PERFORMANCE SPECIFICATION SHEET

SEMICONDUCTOR DEVICE, FIELD EFFECT TRANSISTOR, N-CHANNEL, SILICON
TYPES 2N6796, 2N6796U, 2N6798, 2N6798U, 2N6800, 2N6800U, 2N6802, AND 2N6802U
JAN, JANTX, JANTXV, JANS, JANHC, AND JANKC

This amendment forms a part of MIL-PRF-19500/557F, dated 9 December 1997 and is approved for use by all Departments and Agencies of the Department of Defense.

FIGURE 1. outline drawing, delete and substitute:

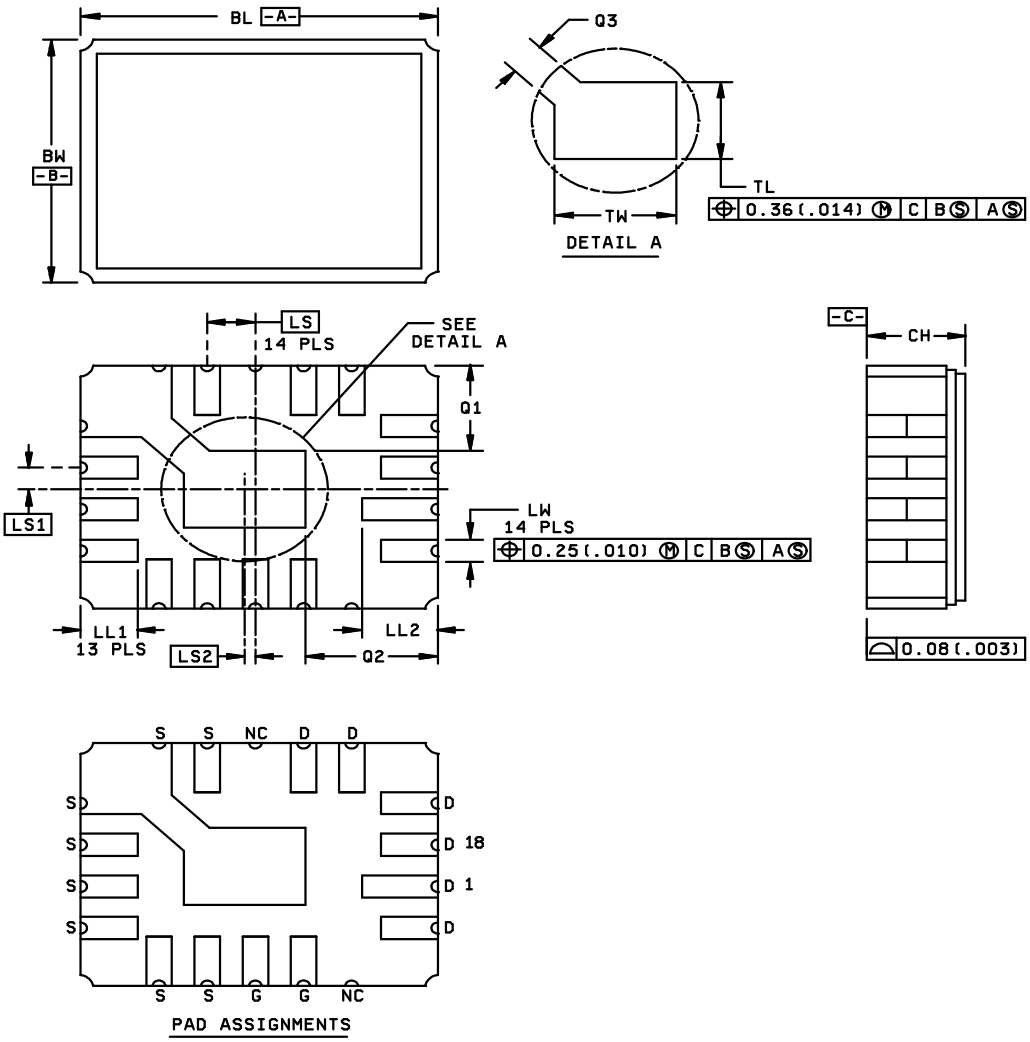
FIGURE 1, dimensions table, CD measurement, delete ".335" and substitute ".355"; delete "8.51" and substitute "9.02".

FIGURE 1, dimensions table, P measurement, delete ".100" and substitute ".070", delete "2.54" and substitute "1.78".
